Project No.: 17275-1

Re: *Proposed Secondary Plan for Promenade Centre (“the Centre”)*
Promenade Limited Partnership (“PLP”)
Summary of Comments

7411-07
Promenade Shopping Centre –
Master Plan

SUBJECT: REVIEW OF PUBLIC/PRIVATE STREETS AND CORRESPONDING RIGHTS-OF-WAY –
PROMENADE SHOPPING CENTRE, MASTER PLAN

Schedule C LAND USE PLAN

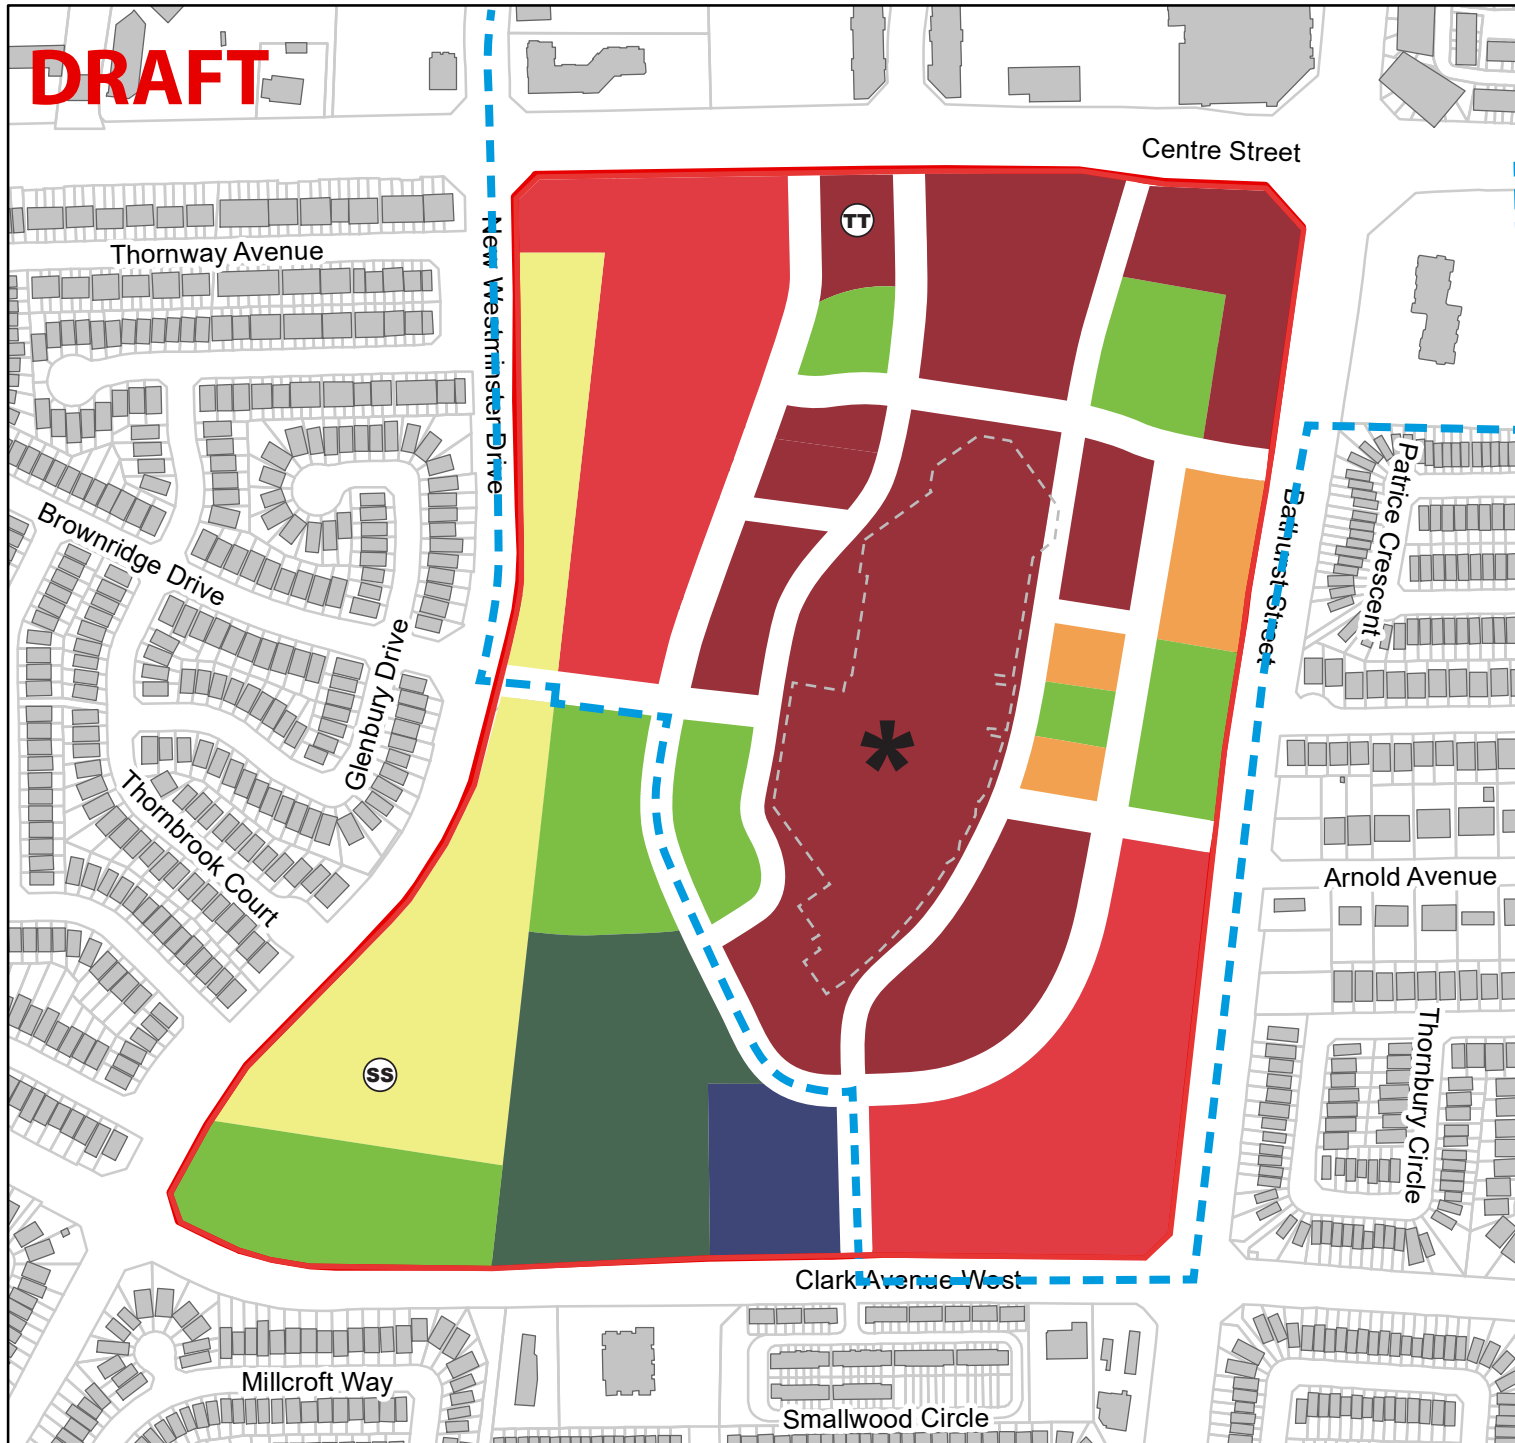
The park designations on Schedule C (and D) are located conceptually throughout the community and include both new and existing parks. Policies 3.8.2 and 6.1 indicate that the **total** parkland (including new and existing) within the Secondary Plan area should “generally” be a minimum of 5.98 ha. There is no policy setting out how the 5.98 ha was determined, nor what existing and /or proposed parks this number includes. With respect to the PLP lands, it would appear that the parkland, as shown on Schedules C/D, currently account for over 10% of their total holdings - a significant amount given the land area devoted to retaining the Mall and recognizing that parkland has already been dedicated on the plan of subdivision for the Mall site (Trudeau Park and Woodlot).

PLP is generally supportive of the parks locations shown. However, it suggests that some minor adjustments are in order as shown on Attachment 1. For example, the park on the PLP lands adjacent to Bathurst Street should be increased and extended north, as shown on Schedules C and D. While conversely, the park shown at the northwest corner of the PLP lands south of Promenade Circle should be deleted as its size and location severely restrict the developability of the remaining parcel to the south.

PLP requests that that the POP locations as shown on Schedules C and D be deleted (see Attachment 1).

PLP requests that Schedules B, C, D and E be revised in accordance with the Revised Schedules included in Attachment 1.

Schedule D

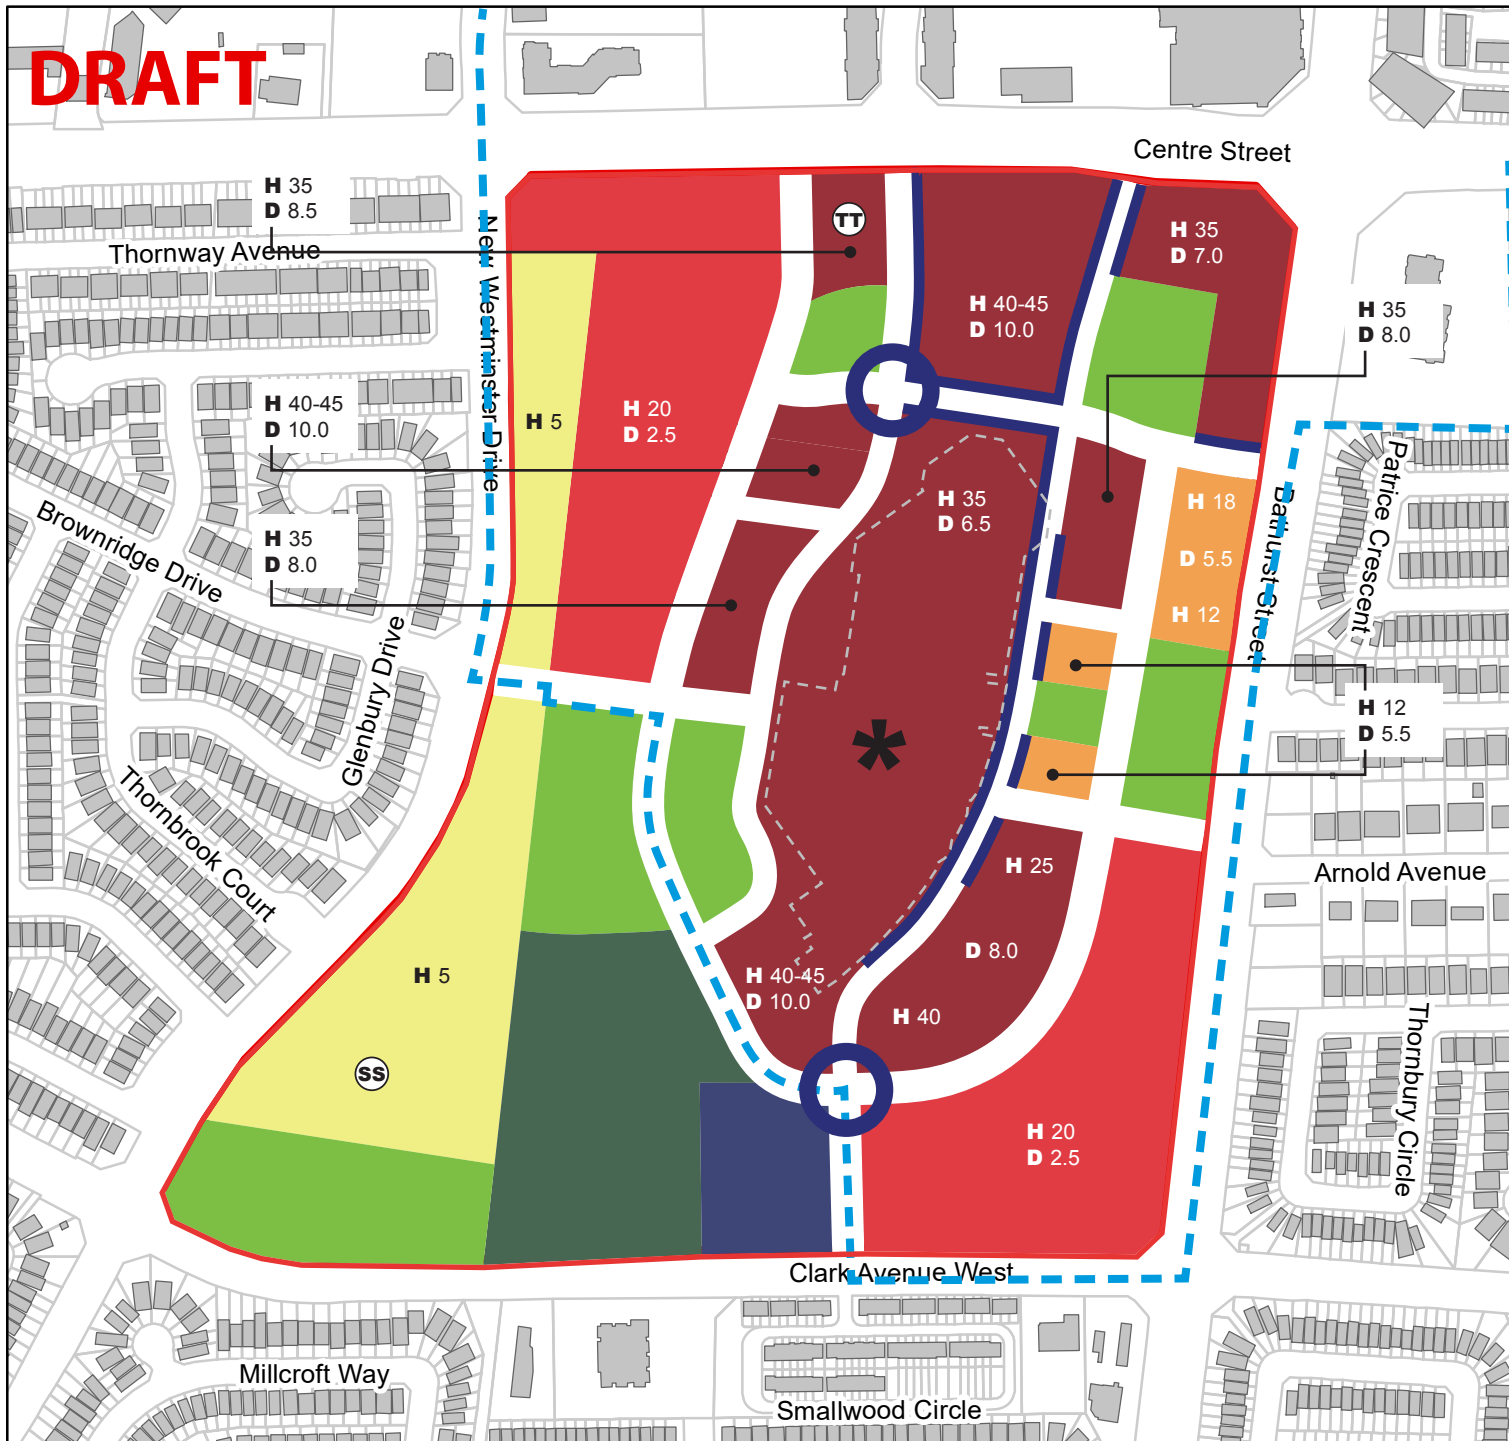
Schedule D provides a height of 35 storeys and a floor space index (FSI) of 6.5 on the entire Mall area. As it is not possible to construct towers over the Mall while continuing to operate it as a regional retail destination, this allocation of density is effectively "frozen". The proposed allocation of so much of the permitted density to the Mall building will effectively prevent the broader Secondary Plan area from achieving the identified population and density targets.

The entire Secondary Plan area falls within an 800 m radius of the Disera Promenade BRT station - thus all uses will be within walking distance of the station. The basis for the limitation of a maximum floor space index (FSI) of 10 within the Transit Hub Precinct and generally only 6-7 for all other buildings shown on Schedule D (Section 3.2.3) is not provided. This restriction is particularly challenging when much of the density allocated to the Mall building (see Schedule D) cannot be used.

The PLP vision has always been for the retention and strengthening of the Mall while transforming the surface parking lots into a high density mixed use development to form a complete community. **PLP requests that additional height and density be allocated to other more appropriate locations on the PLP lands.** (see Attachment 1 and Paragraph B b. below). The allocation of this additional density, as set forth in Attachment 1, is necessary to both ensure

PLP requests that the maximum heights and FSI be increased in key locations as shown on Attachment 1 and that the FSI shown be calculated on a gross not a net basis.

Schedule E

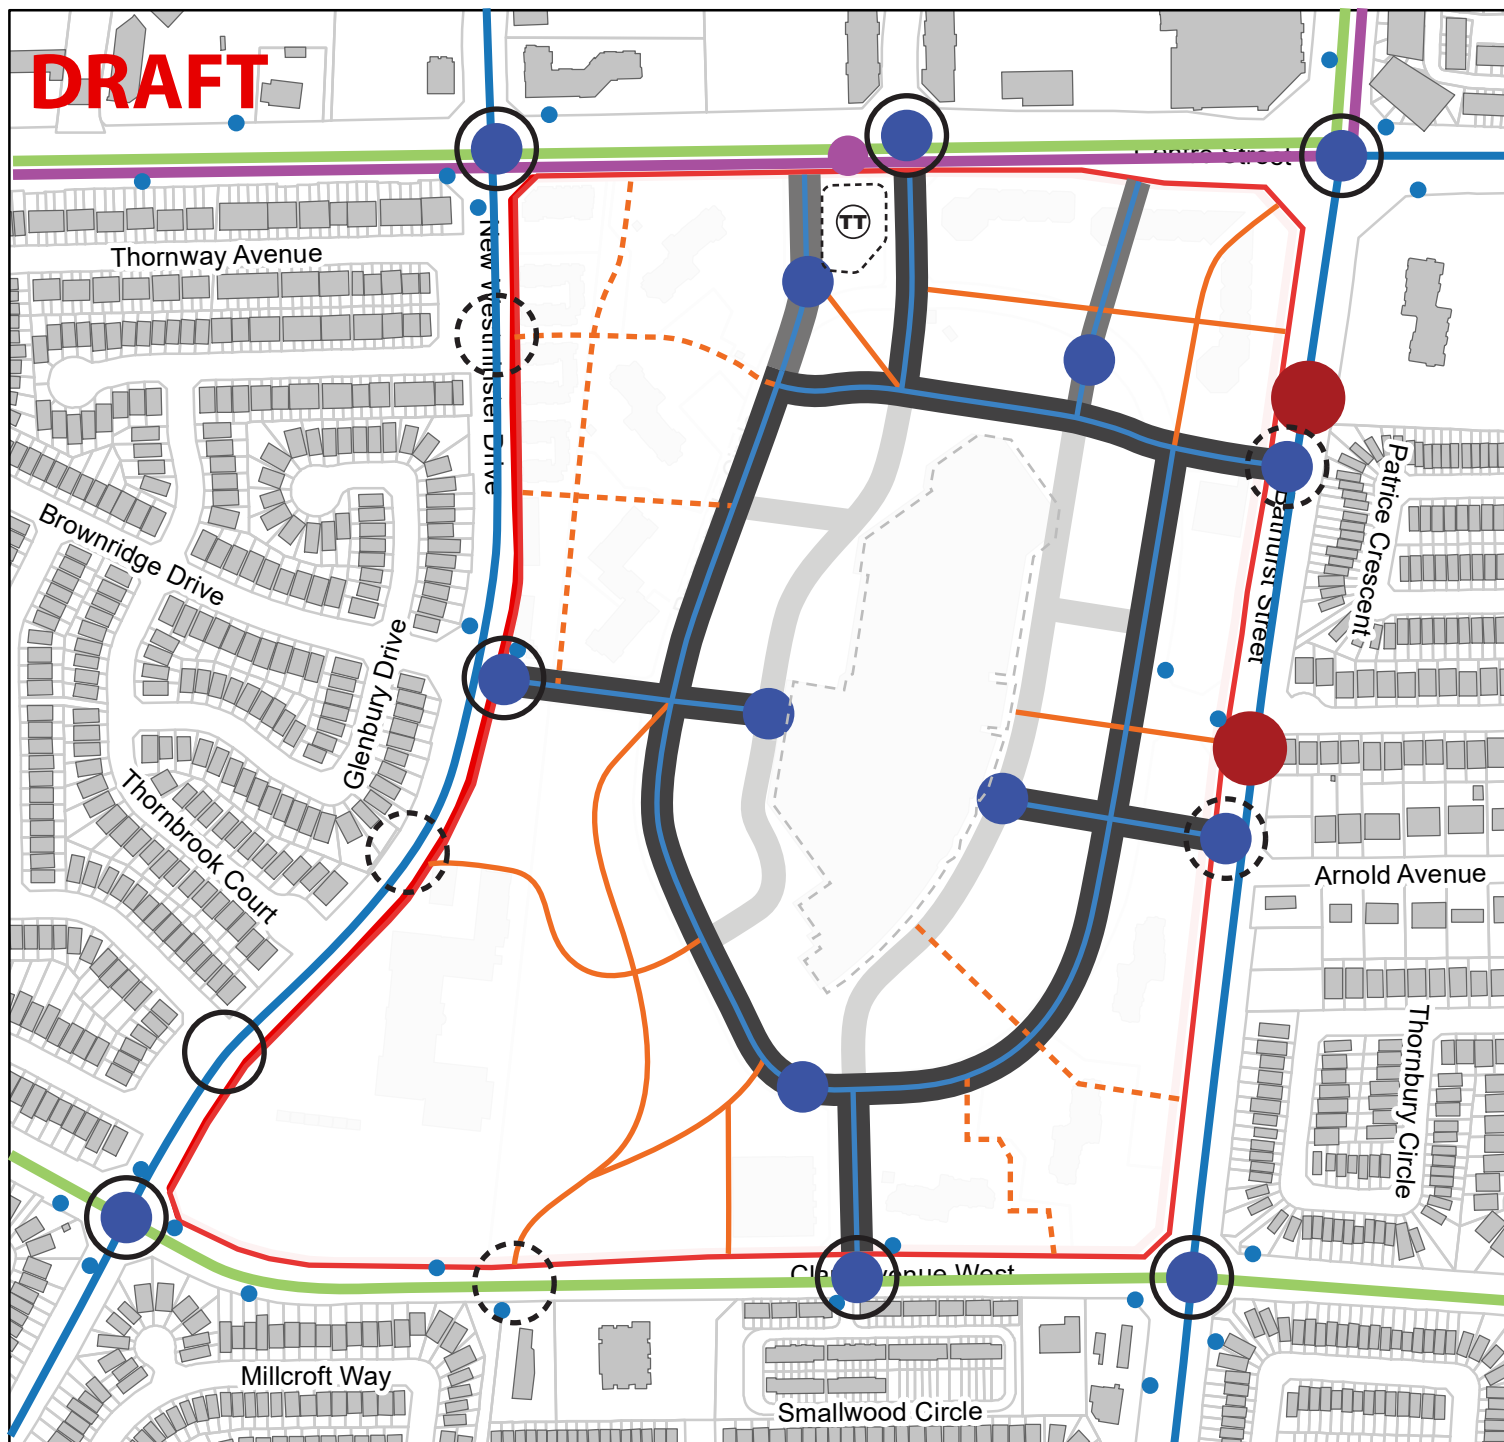
5.2.f ii and iii - in order to clarify that the Long Term Future Road Connection on Schedules C, D and E would only occur in the event of a very long term redevelopment of the Mall.

FD-01

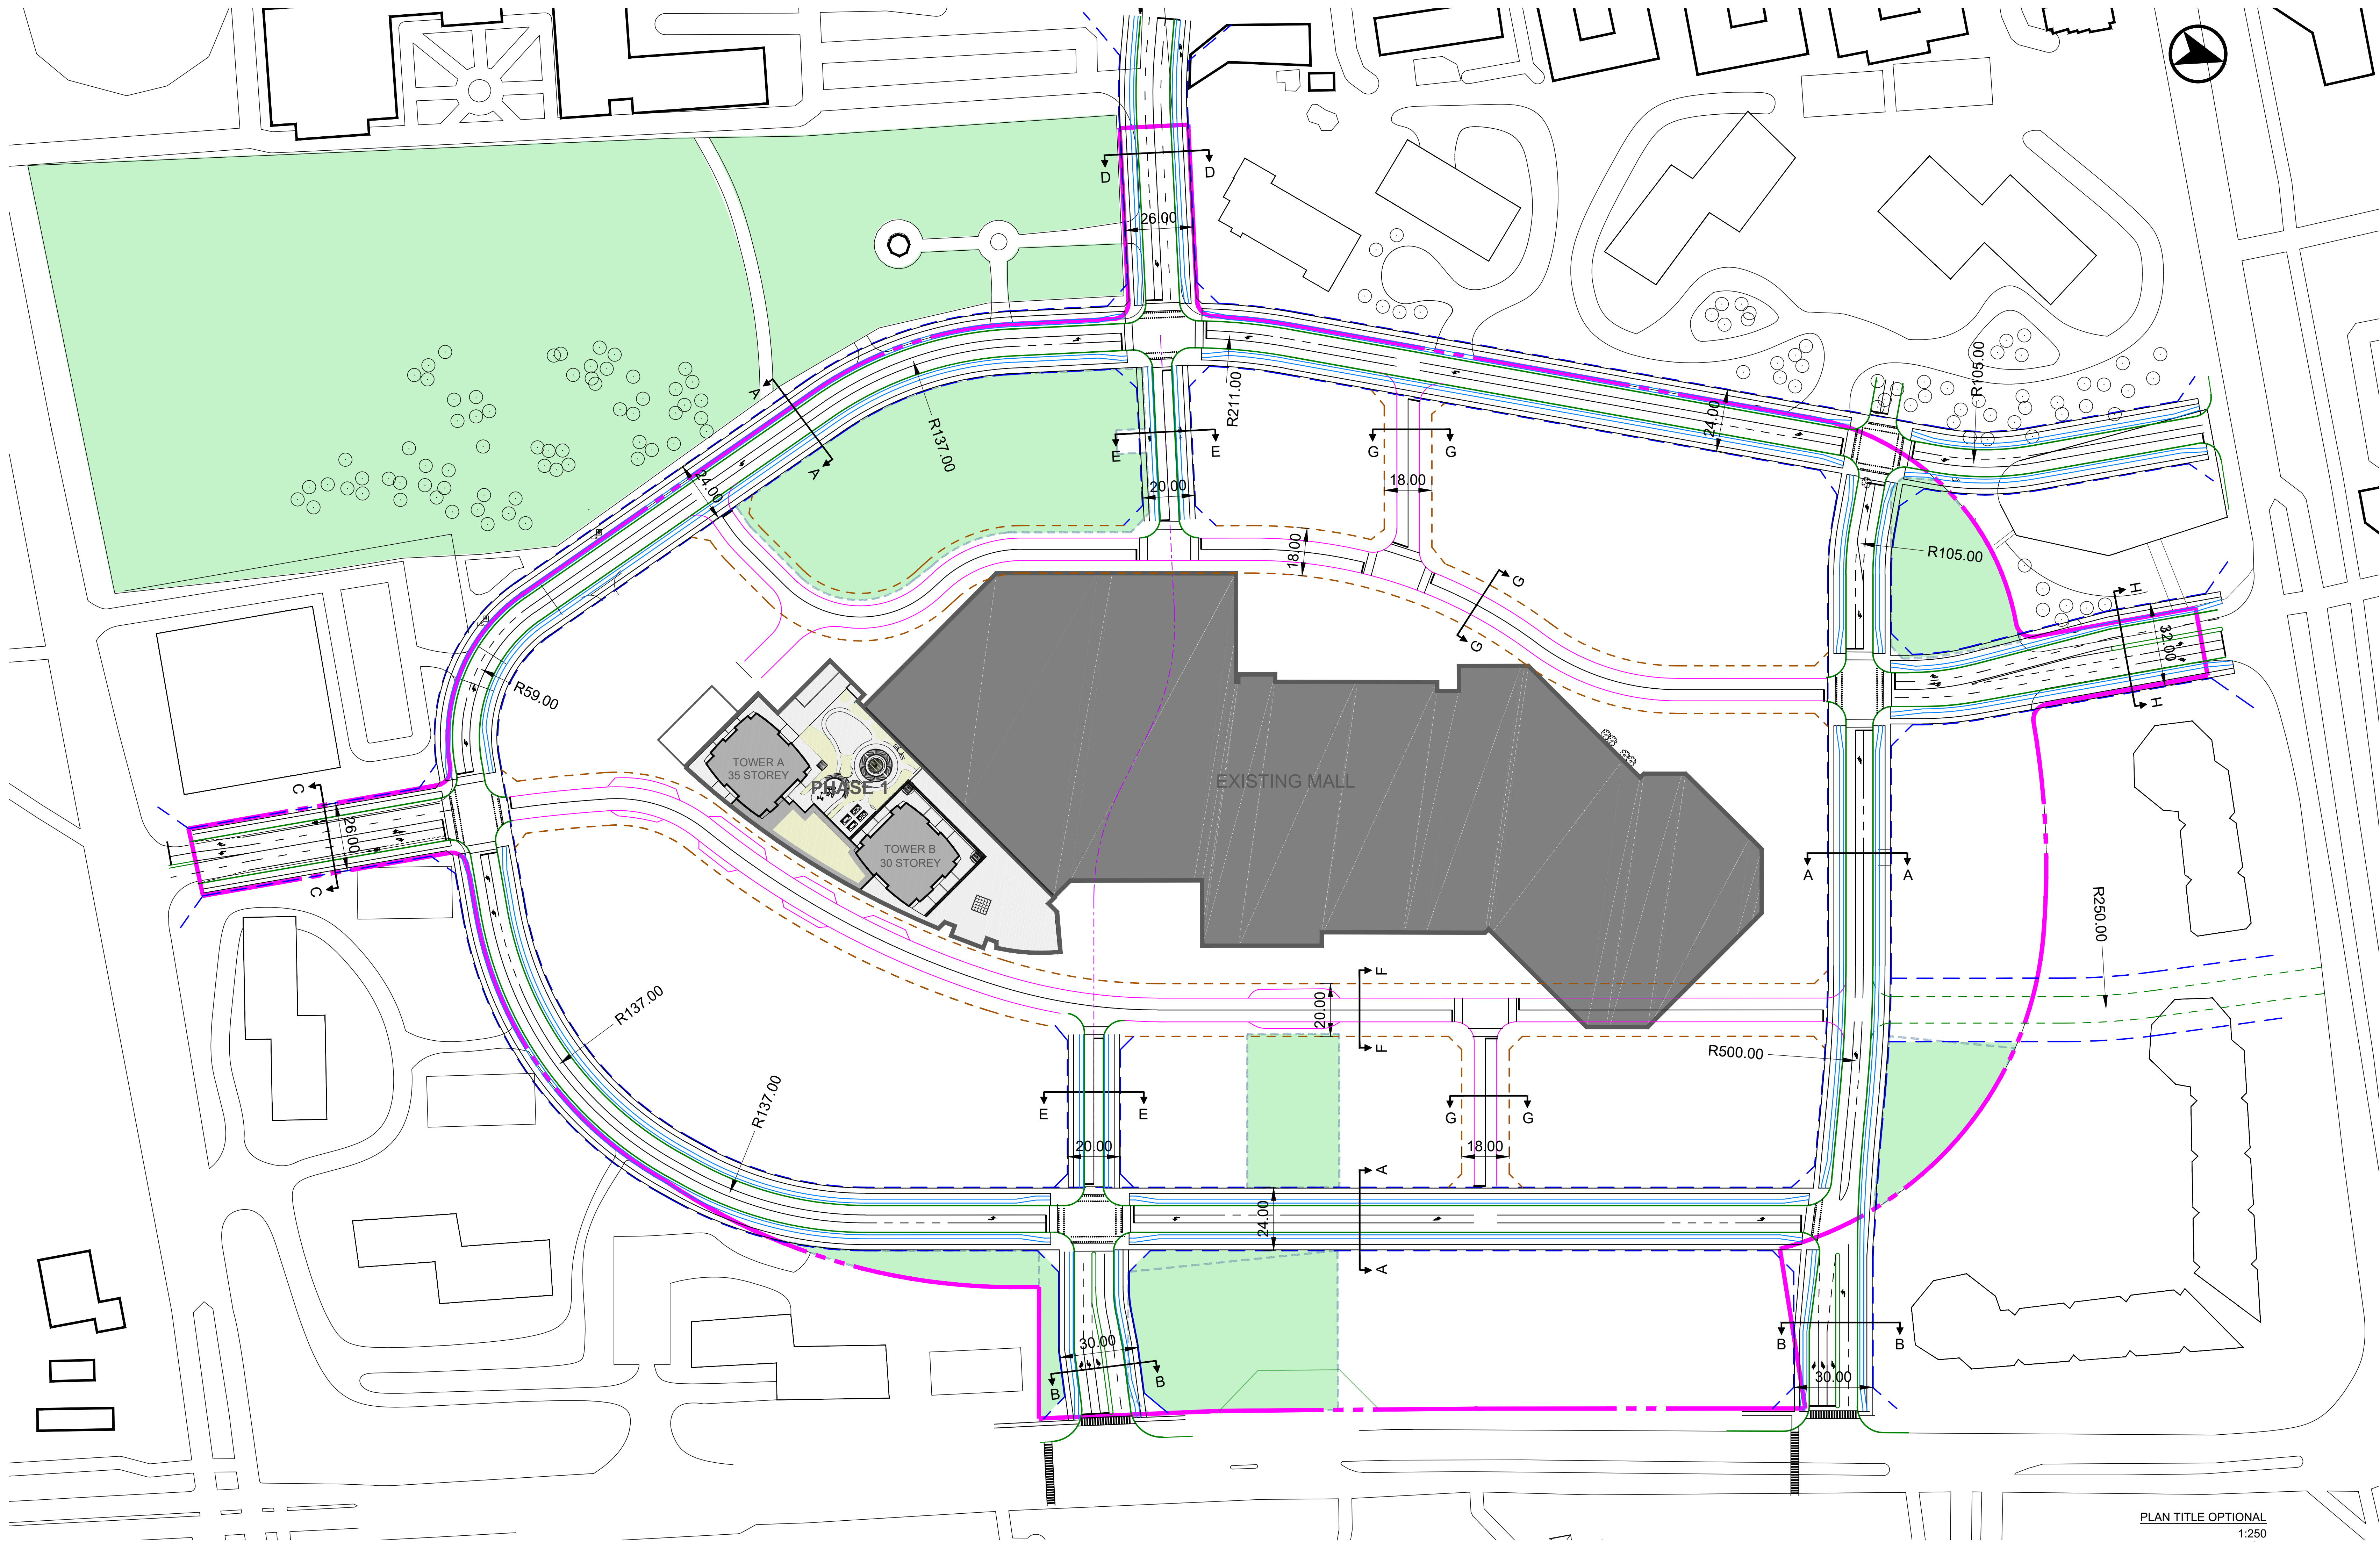
PLP has proposed that the **Collector Streets** that form part of the Master Plan street network **will be Public Streets**. This is consistent with the Secondary Plan assumptions proposed by the City of Vaughan and their consulting team. Public Streets are illustrated in a blue colour on Drawing FD-01 in **Appendix A**.

Private streets are illustrated in a pale yellow colour in Drawing FD-01, in **Appendix A**.
